Final
**Remedial Investigation/Feasibility Study
Work Plan**

for
AOC I and AOC R

at the
**Former U.S. Naval Ammunition Support Detachment (NASD)
Vieques Island, Puerto Rico**

August 2004

Figure 4-2
AOC I Proposed Soil Sample Locations
Former NASD, Vieques, Puerto Rico

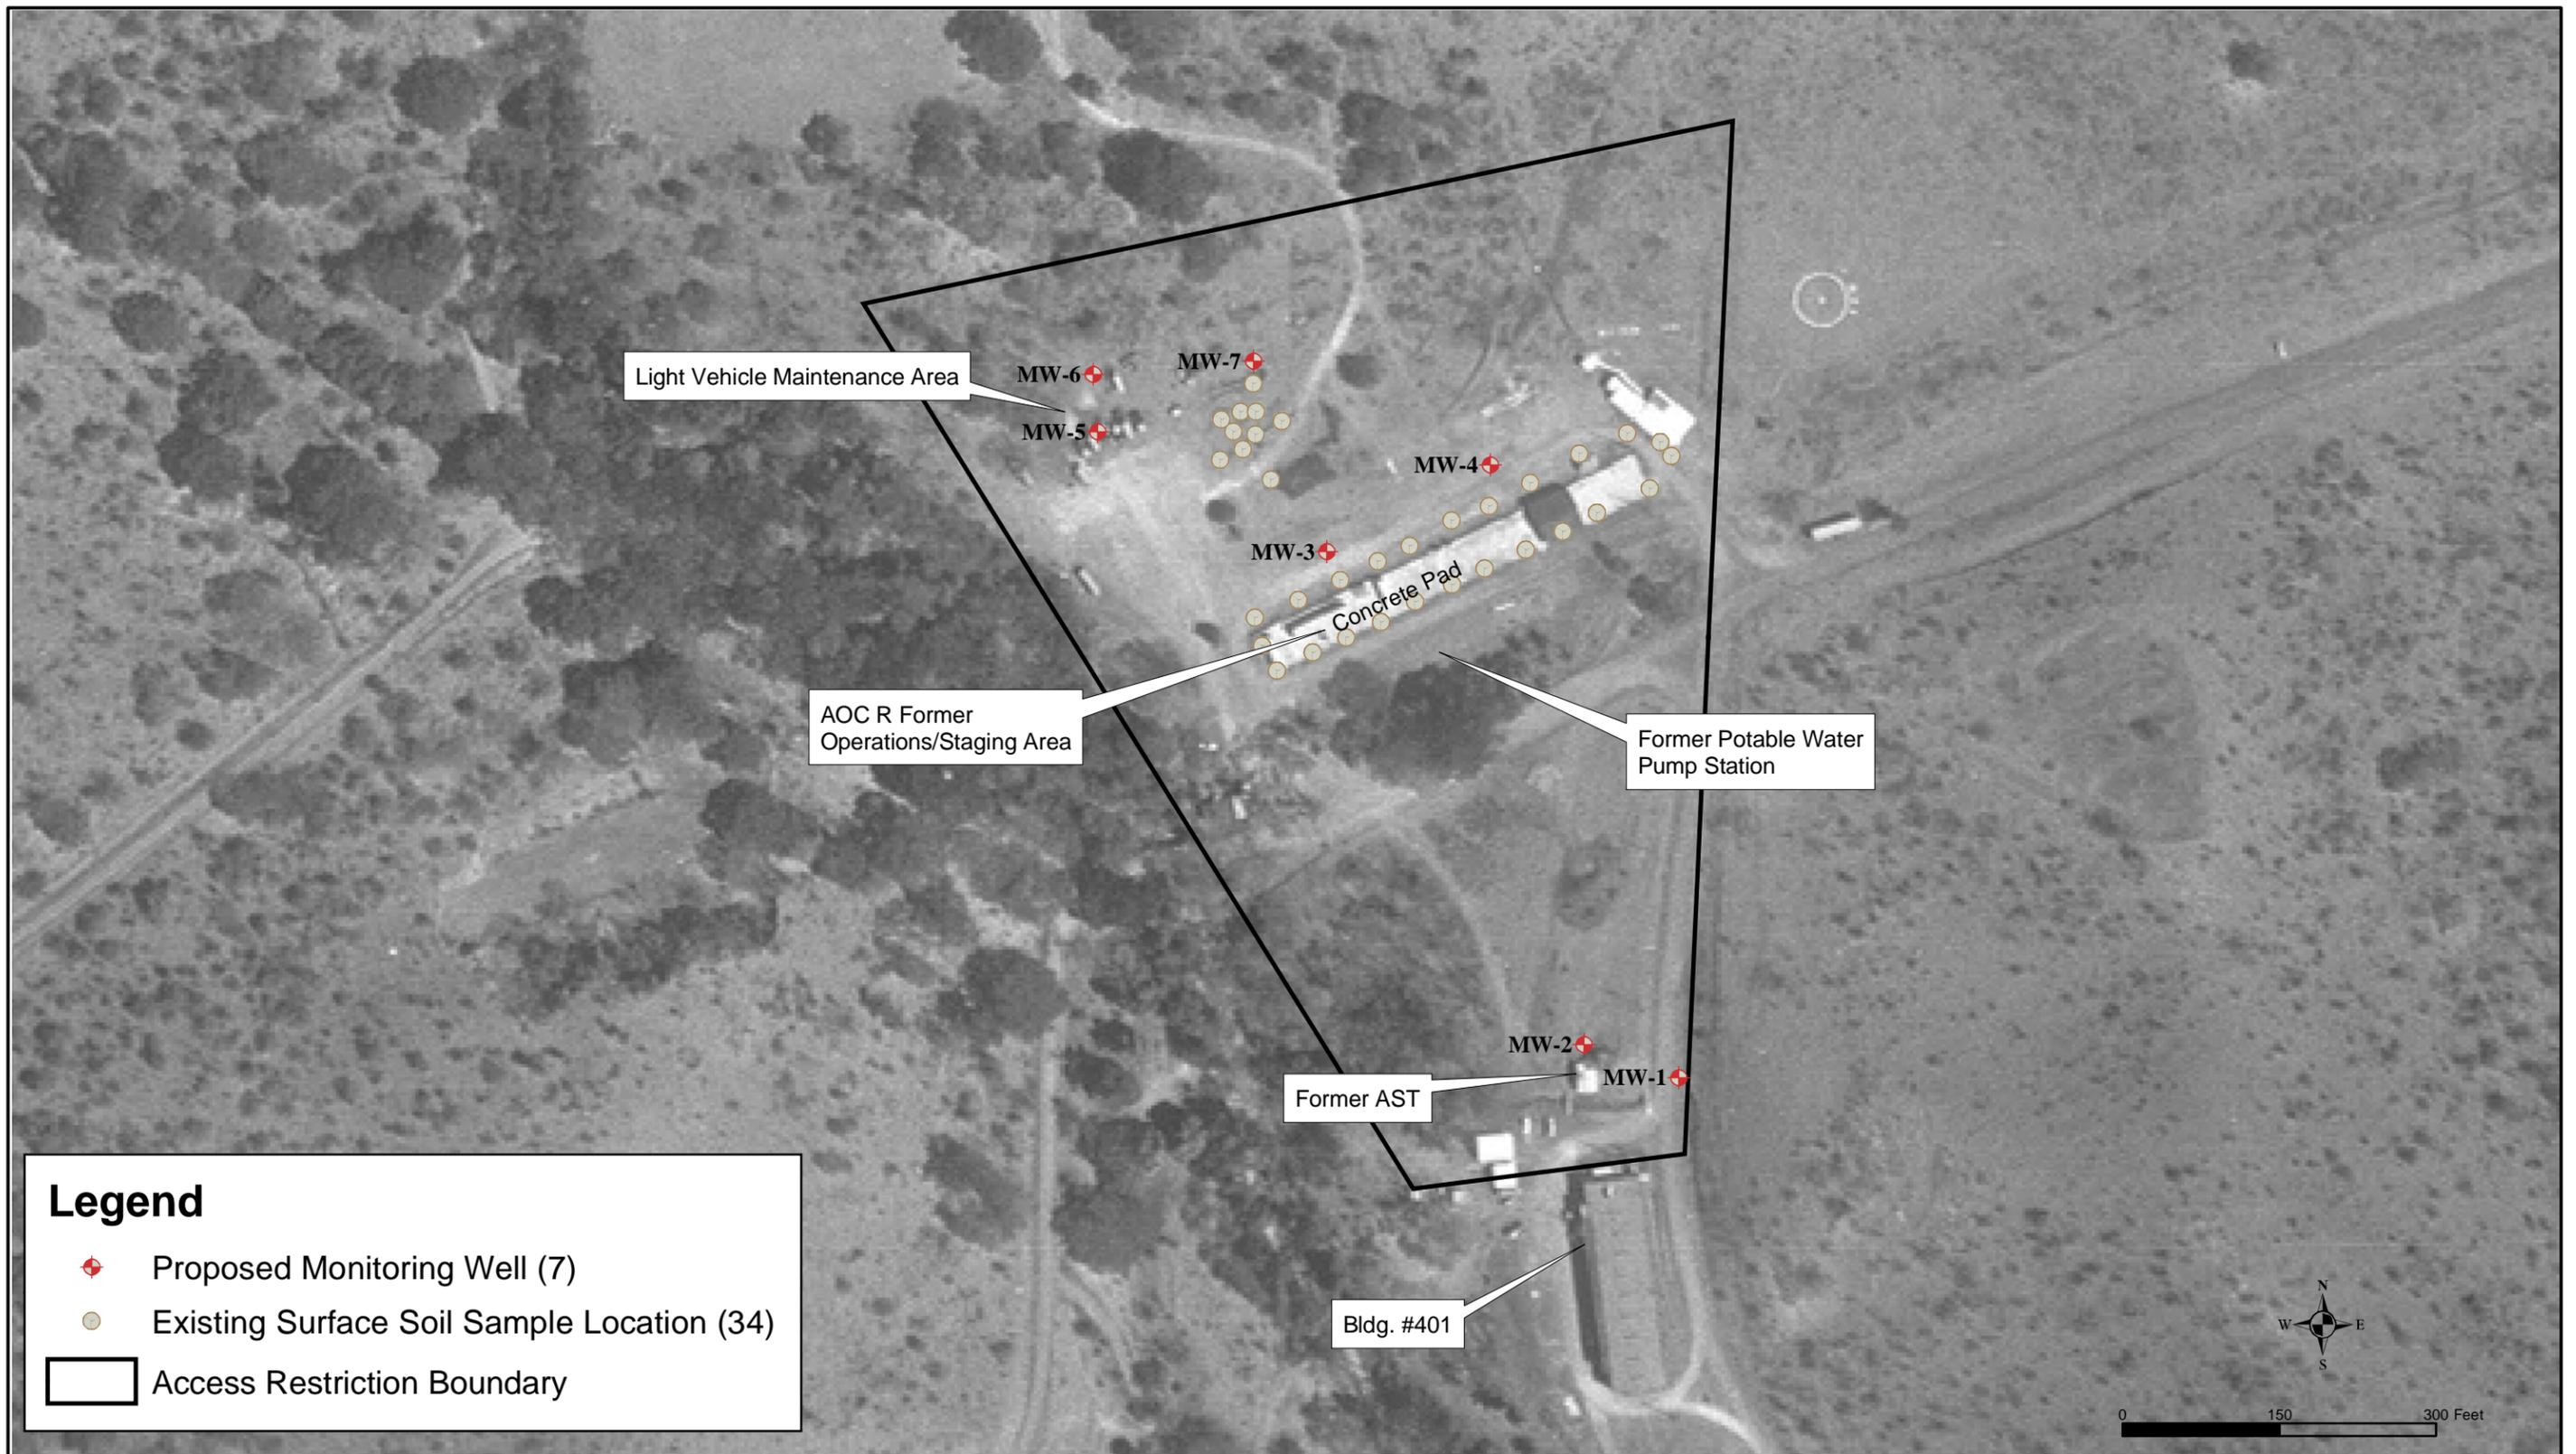
Section 4.1 Data Quality Objectives, Table 4-1 (AOC I): During the PA/SI metals were found in surface soil. Therefore it is recommended that the forthcoming sampling include metals in surface soil. It is recommended that the 12 surface soil sample locations identified for TPH/SVOC (Figure 4-2) include metals analysis.

- b) **Two additional surface soil samples will be collected to the west of SB-01 and SB-03. Locations are shown on Figure 4-2.**
- c) **New surface soil samples will be analyzed for hexavalent chromium and total chromium. Section 4.3.1.4, paragraph 3, will be edited to show this. The total chromium in several soil samples exceeded the background and leachability screening value (SSL) but none of the total chromium concentrations exceeded the human health based screening value. The SSL for chromium assumes that chromium is present in the hexavalent state; trivalent chromium has low solubility and is not considered a leaching hazard. Therefore, chromium at the site represents only a potential leaching hazard. The proposed speciation of chromium via total and hexavalent chromium analysis will determine whether the site soil total chromium concentrations above the SSL represent a leaching hazard. Therefore, the intent of the proposed sampling is to determine if the soil chromium is in leachable form. Thus only a portion of the samples are proposed for the leachable form determination. Hexavalent chromium is not known to have been used at the site and is not a typical constituent or contaminant at asphalt hot mix plants. Therefore, it is unlikely that hexavalent chromium is present at the site. Six subsurface**

Figure 4-3
AOC R Proposed Monitoring Well Locations
Former NASD, Vieques, Puerto Rico

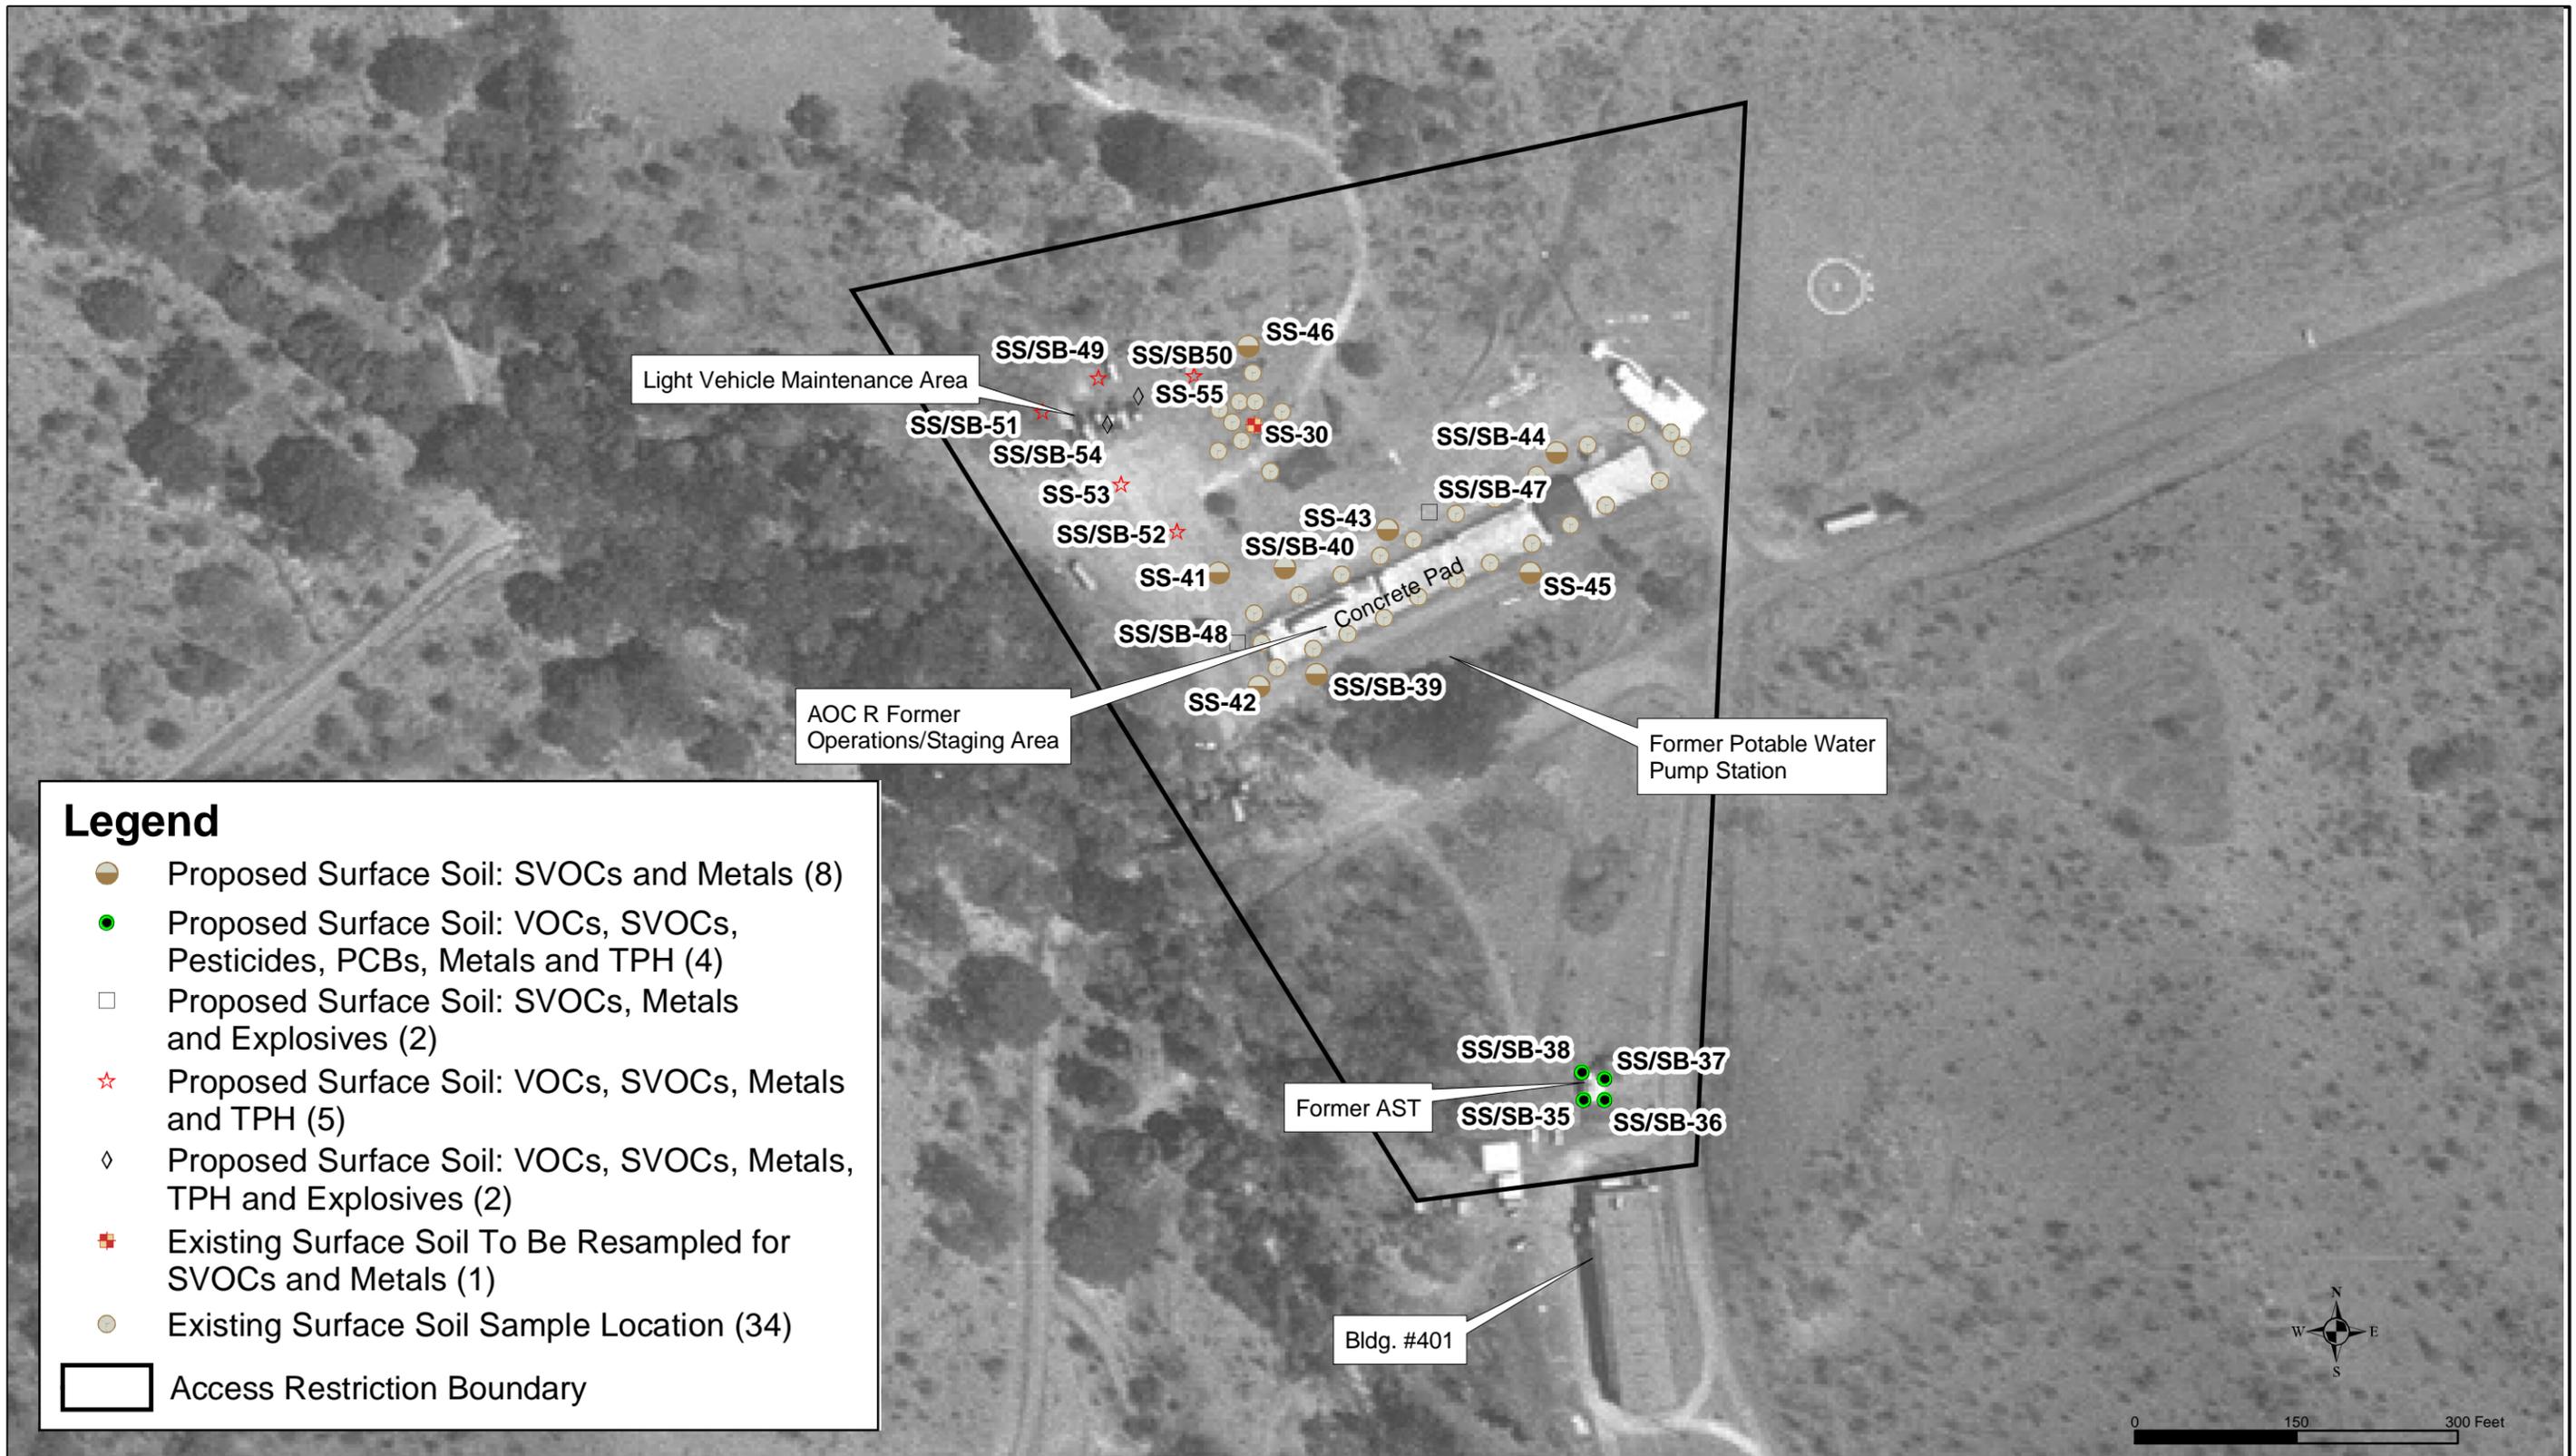
Monitoring well locations, Figure 4-3: A well should be placed in the center of the vehicle maintenance area (e.g. Near SS-27) to determine if groundwater has been impacted right in the likely source area. Similarly, a well should be located just north of the pad for the AST. Other proposed wells may be shifted so that this does not require additional wells beyond those proposed.

of the former carpentry shop. A monitoring well should be placed adjacent and downgradient from the former mechanics shop. Please correct location of MW05 and MW06. The text refers to MW05 located to the northwest and MW06 located to the northeast; however, figure 4-3 is not consistent with this description.

Figure 4-3 – It appears that there is a heavily vegetated area just west of the site that may represent a stream area, presumably at a lower elevation. Groundwater will likely flow in a westerly or northwesterly direction towards this depression. MW-2 should be relocated to be immediately west of the former AST and MW-2 should be relocated to be due north of the tank, and much closer than

One monitoring well will be moved in the center of the vehicle maintenance area to determine if groundwater has been impacted in this area. Monitoring well MW-2 has been relocated to a location directly downgradient of the AST pad. Figure 4-3 has been revised to display these changes. Section 4.3.2.1 has been edited to describe this.

The location of the former carpentry shop is unknown. There is no known former mechanics shop at the site. Figure 4-3 has been revised to re-locate the monitoring well locations.

Monitoring well MW-2 has been shifted to a location directly downgradient of the AST pad. Figure 4-3 has been revised to display these changes. Section 4.3.2.1 has been edited to describe this.
